UNITED STATES PATENT AND TRADEMARK OFFICE

APPLICATION NO.	FILING DATE	FIRST NAMED INVENTOR	ATTORNEY DOCKET NO.	CONFIRMATION NO.
10/817,564	04/01/2004	David S. Graham	GRAMP005/P06002	3810
22434	7590	01/31/2007		
BEYER WEAVER LLP P.O. BOX 70250 OAKLAND, CA 94612-0250			EXAMINER NGUYEN, JIMMY H	
			ART UNIT	PAPER NUMBER
			2629

Office Action Summary

DETAILED ACTION

FIG. 1

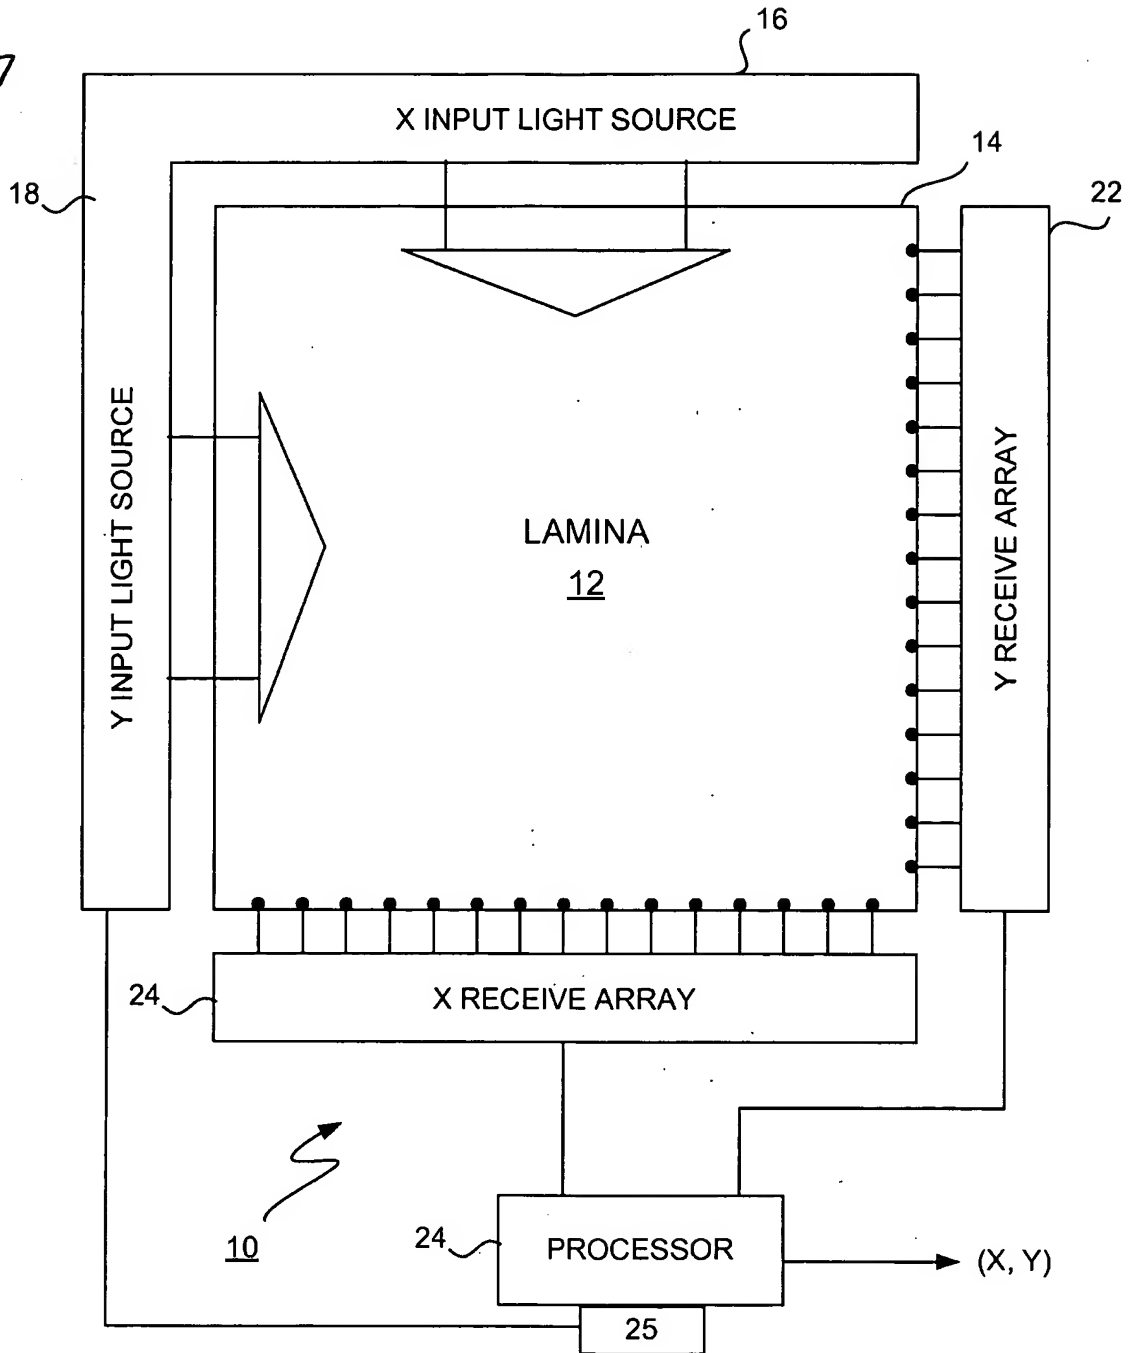
3. The replacement drawing was received on 12/20/2006. This drawing is not acceptable because there is nowhere in the original disclosure to teach the location of the element 25 as shown in the replacement sheet of Fig. 1. Also, note that reference character "24" has been used to designate both "X receive array" and "Processor".

With respect to the drawing objection for failing to show the limitation, “a sleep mode element” of claim 23 in the Office action dated 11/13/2006, Applicant amended Fig. 1 to show a sleep mode element 25. In order to avoid a new matter added to the original disclosure, Examiner withdraws this objection. See the drawing disapproval above.

Disapproved
JHN
1/24/2007
